RAI 5:

Response to Request for Comment on Draft Safety Evaluation for AREVA Inc. Topical Report EMF-2328(P)(A), Revision 0, Supplement 1, Revision 0, "PWR Small Break LOCA Evaluation Model, S-RELAP5 Based" (TAC No. ME8227)

EMF-2328(NP)(A)
Revision 0
Supplement 1
Revision 0

PWR Small Break LOCA Evaluation Model,
S-RELAP5 Based

Figure 5-35: Break Mass Flow Rate – CE 2x4

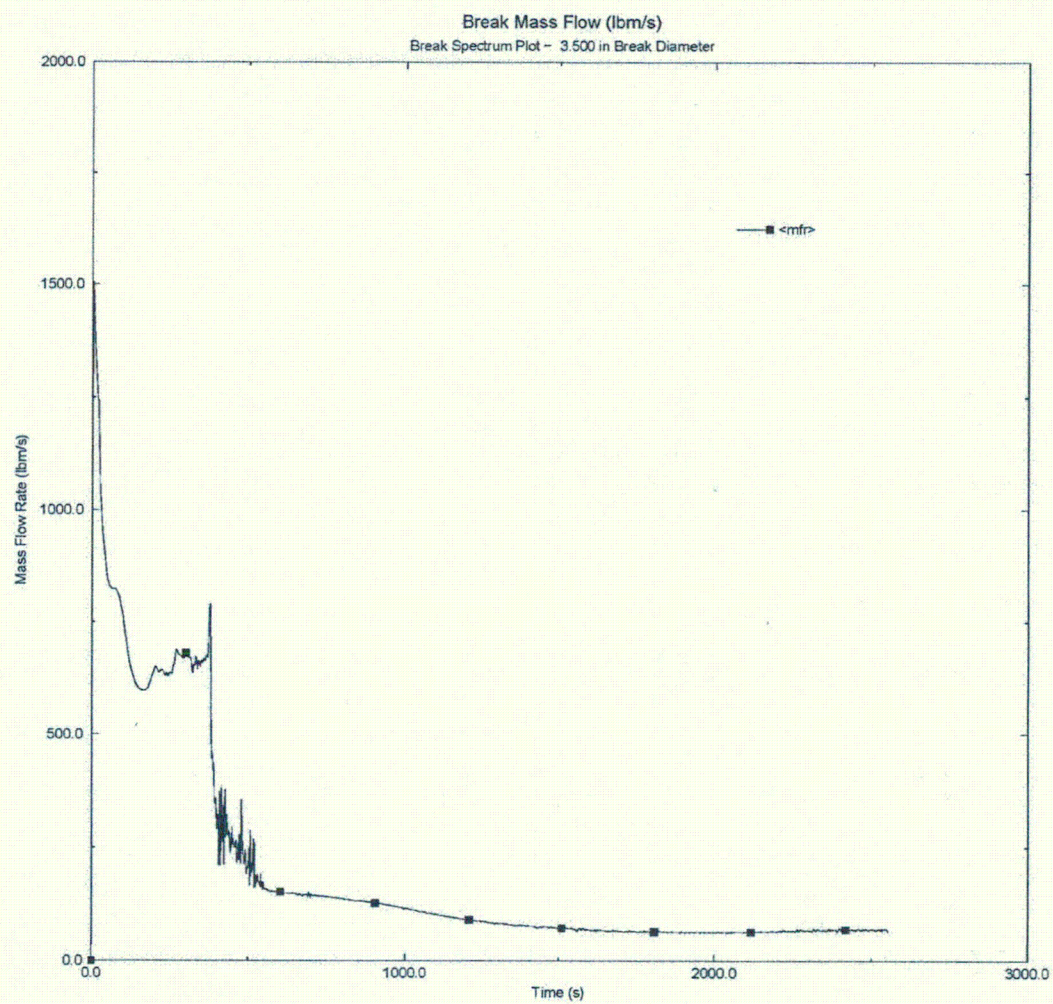
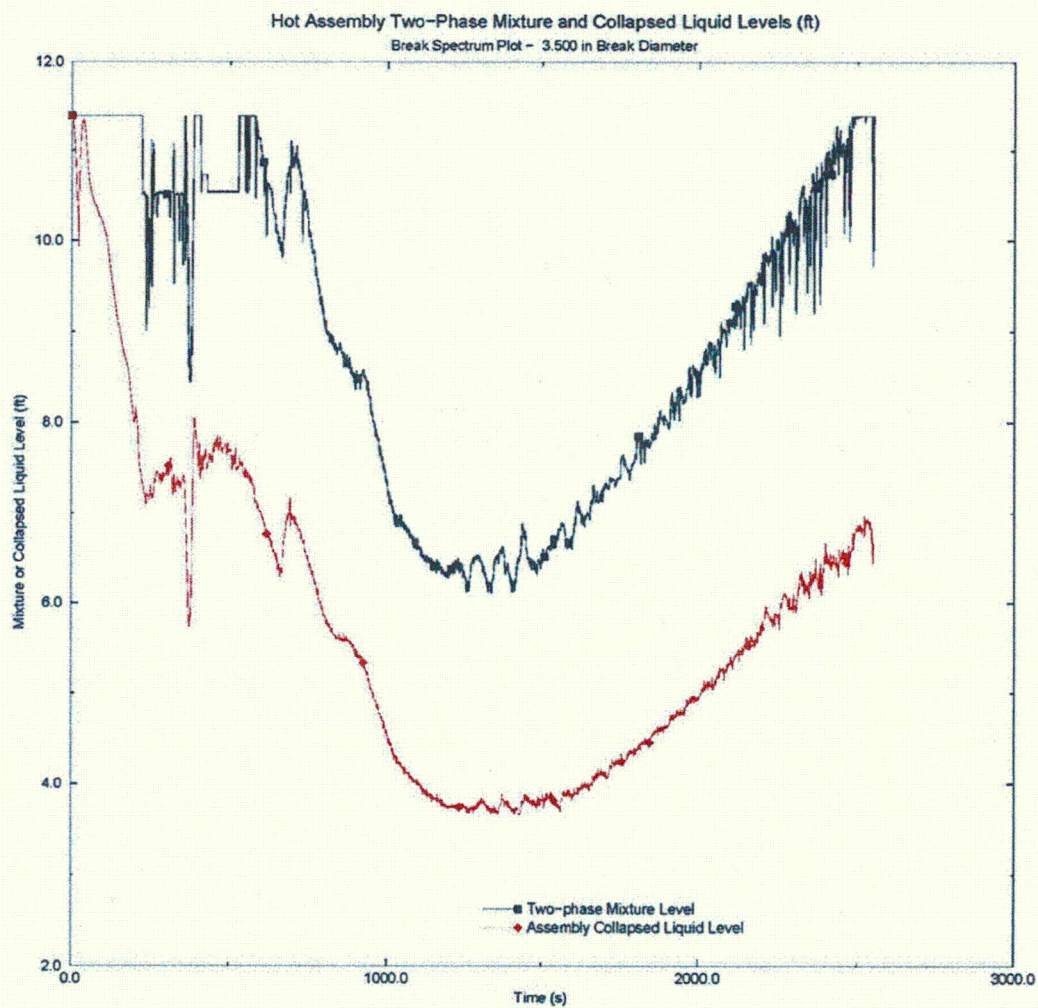
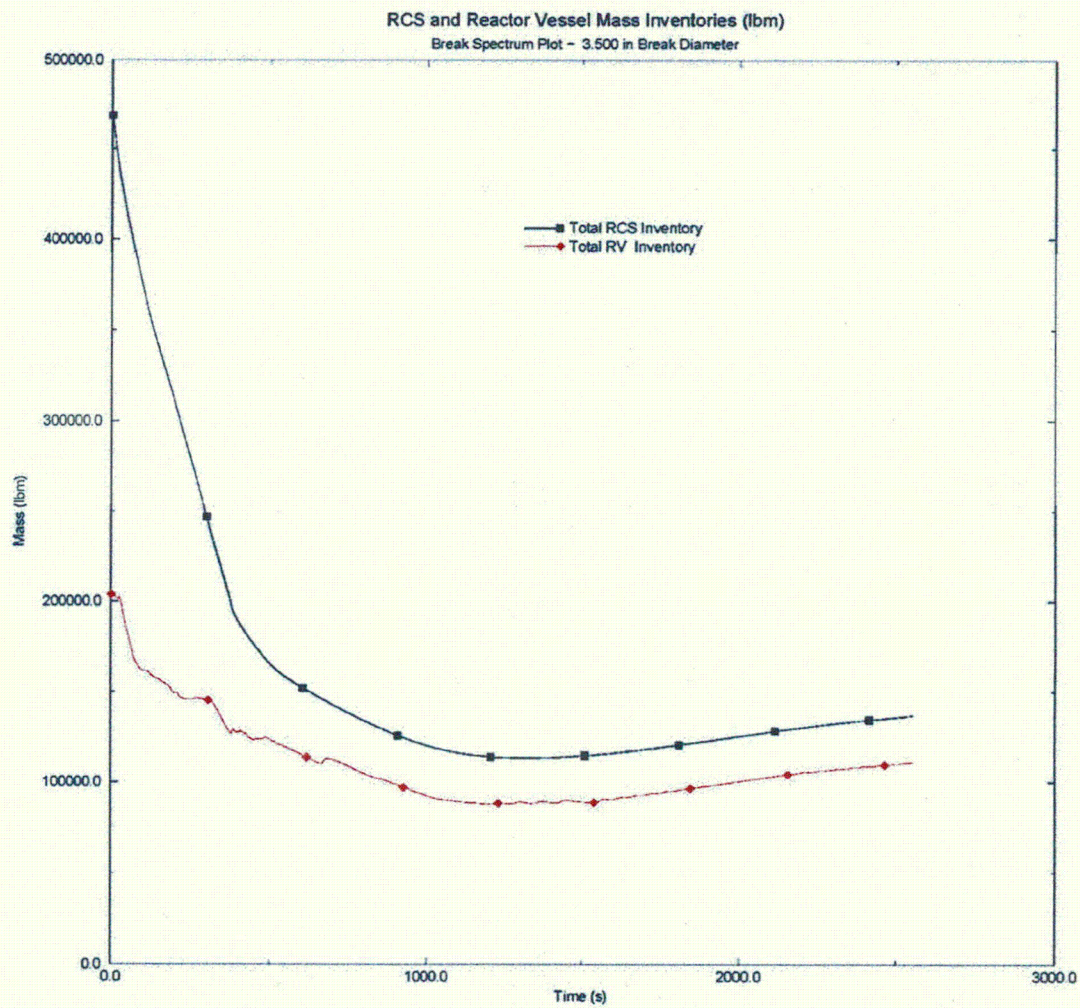
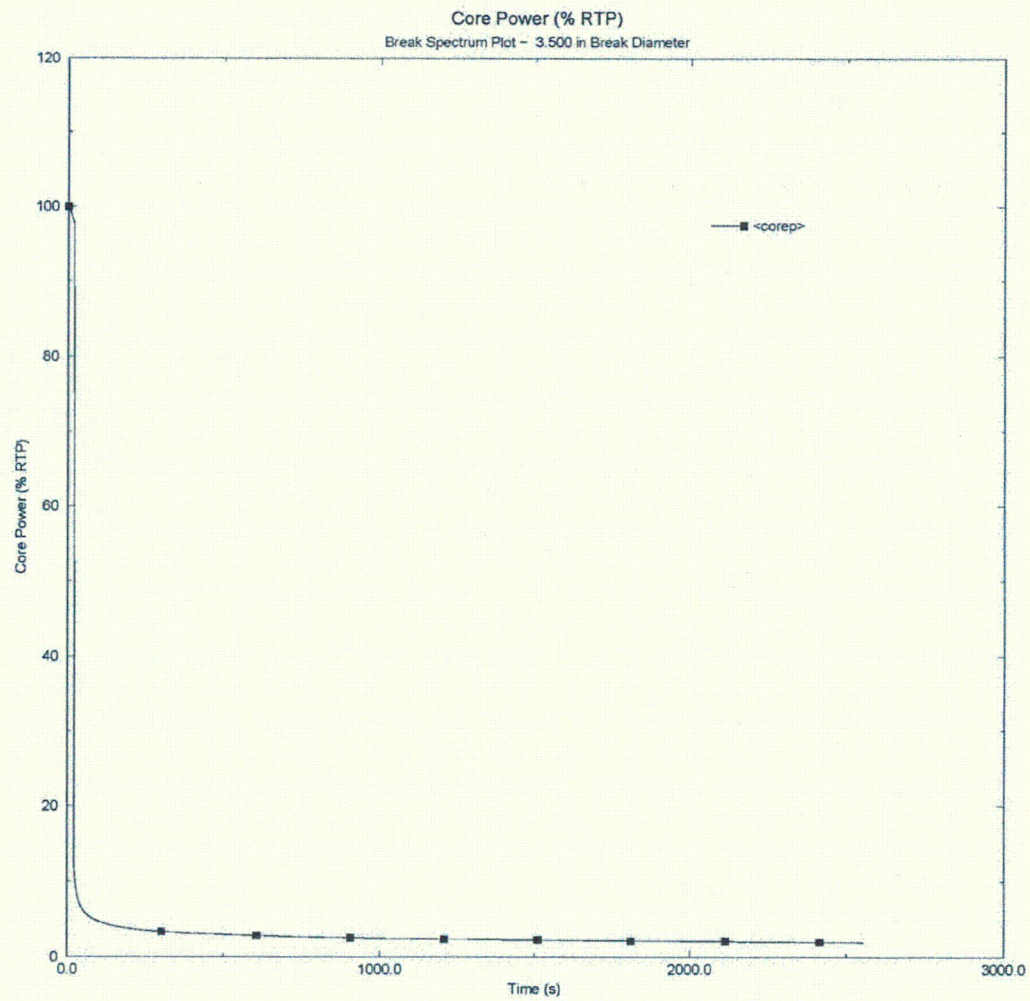
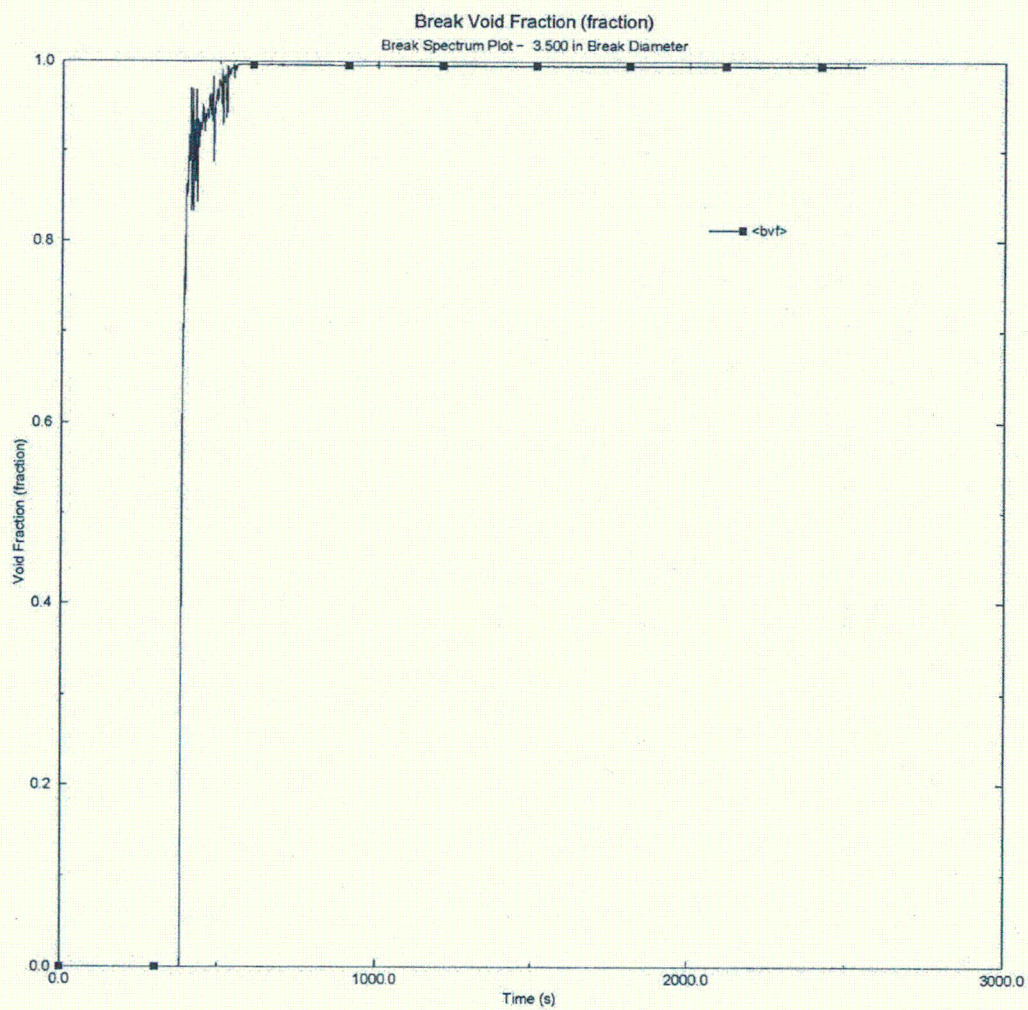
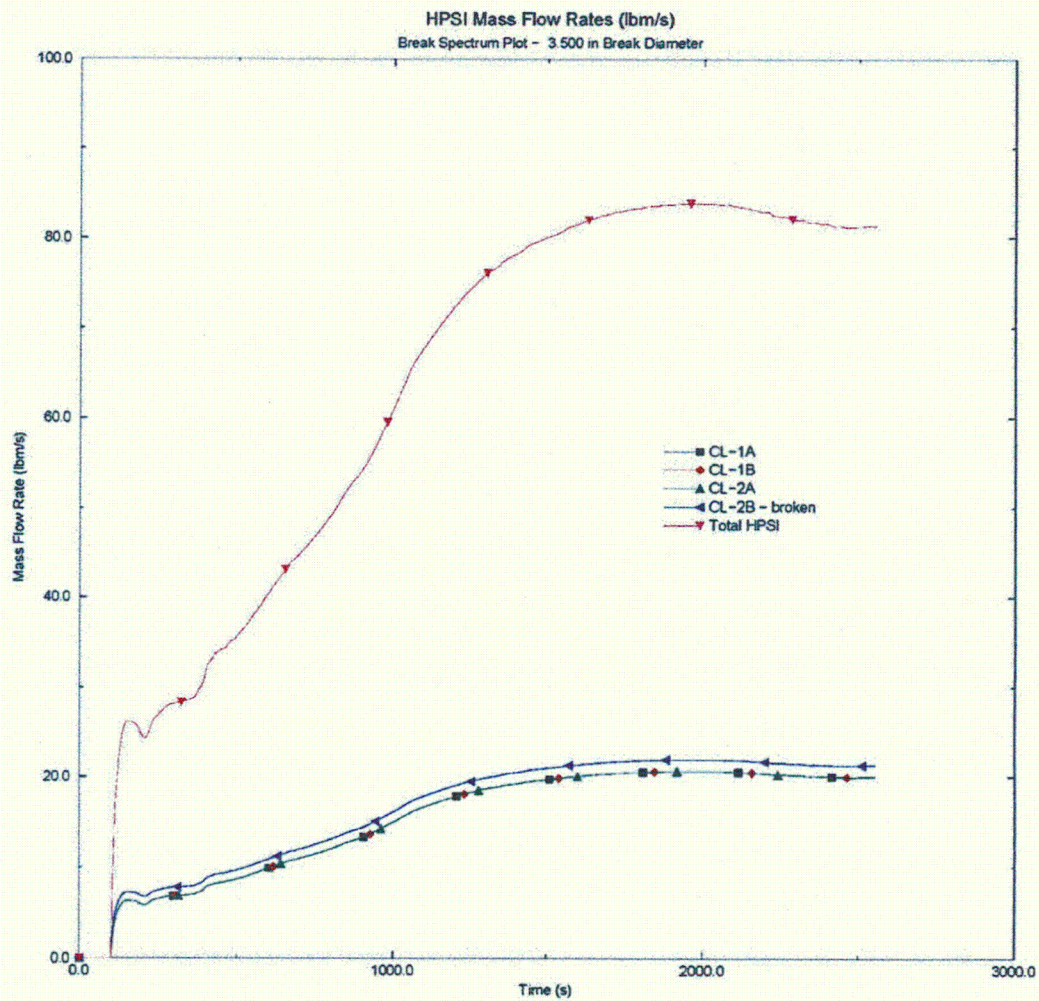
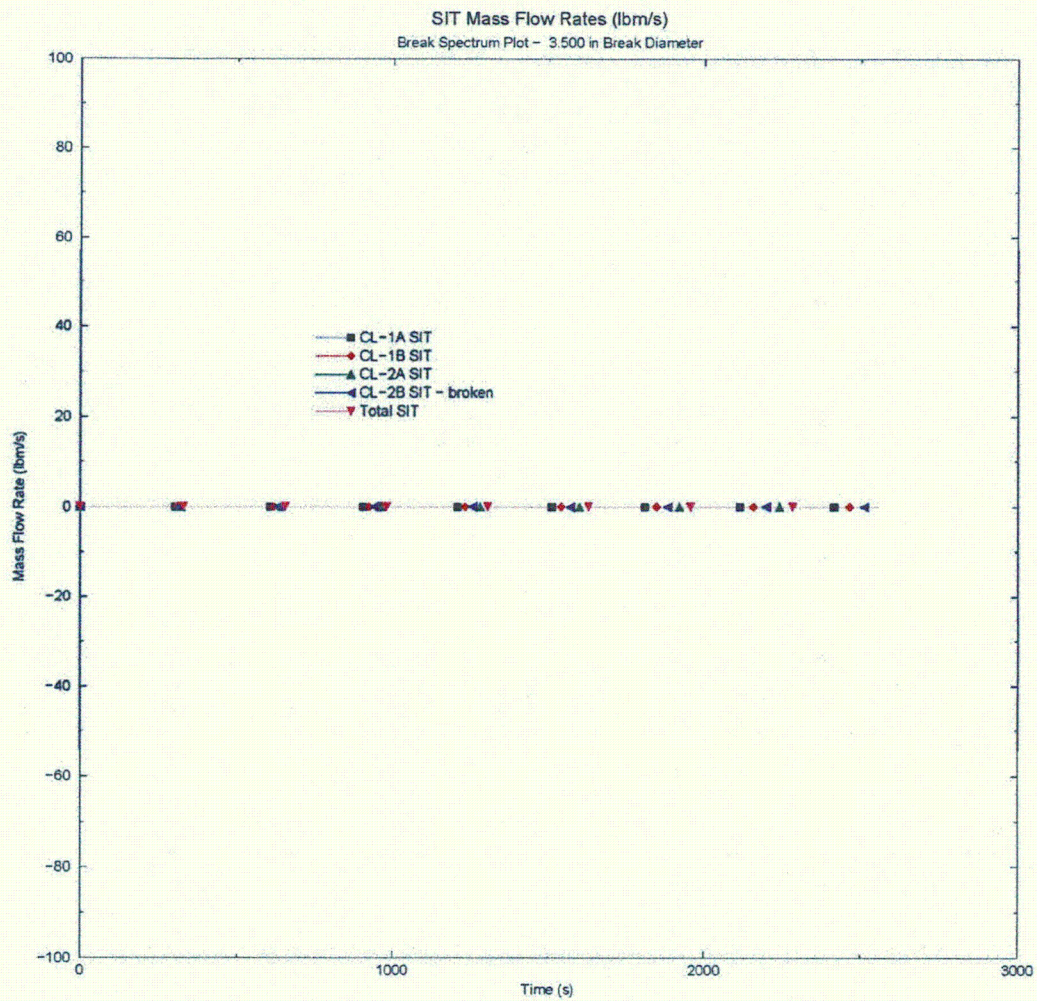
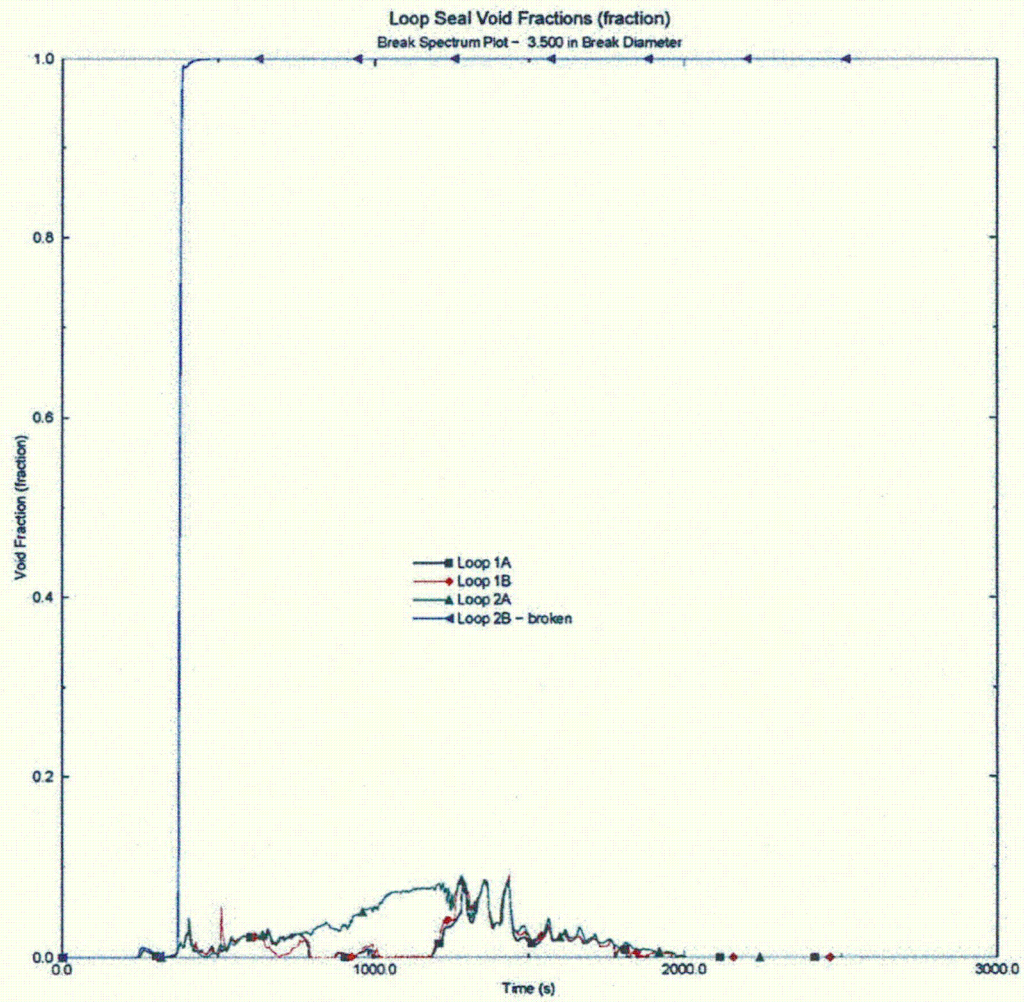
Please provide a plant sample break spectrum analysis with all of the EMF-2328(P)(A), Revision 0, Supplement 1, Revision 0, changes included. This could be accomplished by comparing the results of a sample plant SBLCOA spectrum with and without the EMF-2328(P)(A), Revision 0, Supplement 1, Revision 0, changes. This should include the severance of the safety injection line, as well.

The limiting break for a CLPD break and an SIT line break are presented in Table 5-11 and Table 5-12, respectively. The results from the break spectrum analysis are presented in Table 5-13. The limiting PCT is 1831°F for a 3.50 inch equivalent pipe diameter break size. A listing of the sequence of events for each break size in the spectrum is shown in Table 5-14a through Table 5-14d. Plots of some of the more important parameters for the limiting break of 3.50 inches are presented in Figure 5-35 through Figure 5-50.

A double ended break in the SIT piping connecting to the RCS does not produce a limiting case. An acceptable amount of emergency core cooling flow is delivered to the intact loops.
